D.E.O. FOUNDATION INVESTIGATION
REPORT.
W.J. 61-F-95 -- W.P. 280-60.

Re: Palliser Creek & King's Highway #14, Line 'C',
(Approx. 1/2 Mile West of the Village of Foxboro,
Twp. of Sidney, Hastings County) District #2.

RE: W.P. 280-60
Hwy. No. 14 @ Palliser Ck.
on the Foxboro By-Pass
District No. 8

E.D. 6166		DWG. NO.	
PROCTOR & REDFERN			
CONSULTING ENGINEERS			
TORONTO			
DEPARTMENT OF HIGHWAYS, ONTARIO			
BRIDGE OFFICE, TORONTO			
PALLISER CREEK BRIDGE			
FOXBORO BY-PASS			
THE KING'S HIGHWAY NO. 14			
CO. HASTINGS			
TWP. THURLOW			
LOT 1			
CON.			
GENERAL ARRANGEMENT			
APPROVED:			
DEC 18			
DESIGNED BY: D.E.D.			
CHECKED BY: A.E.H.			
DRAWN BY: J.C.D.			
SCALE: 1" = 10'			
D-4979-A

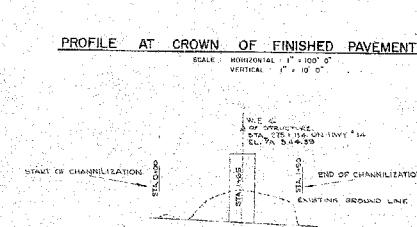
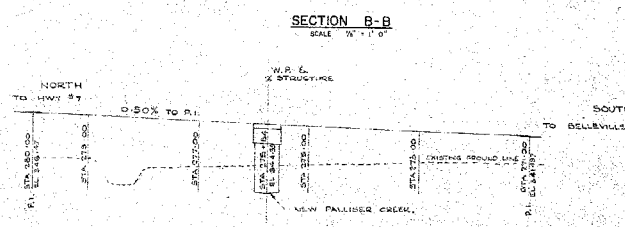
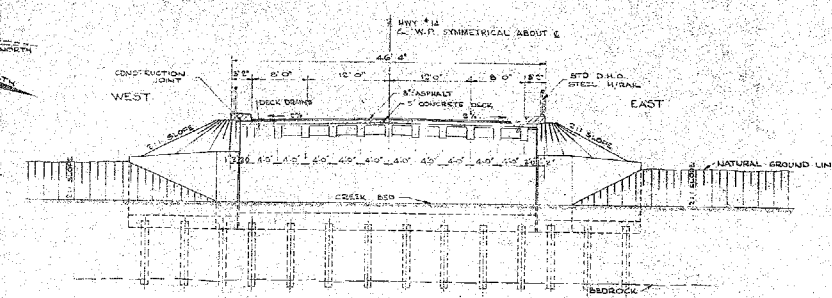
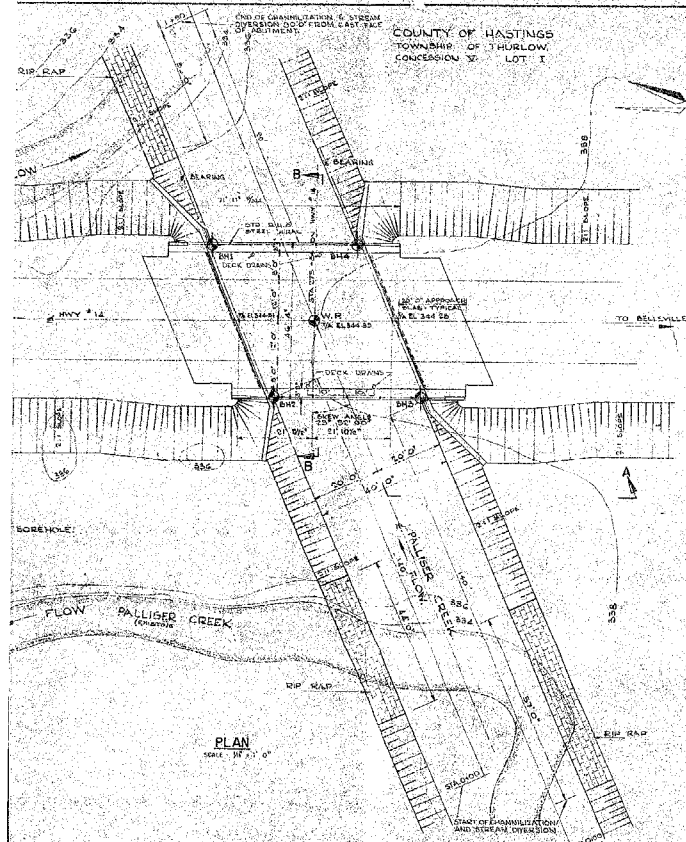
The designer appears to have complied with the
requirements of the foundation report.

We have used steel "H" piles in lieu of the
recommended timber piles due to the fact that they
can be purchased at next to scrap value because of
the short lengths required.

As recommended.
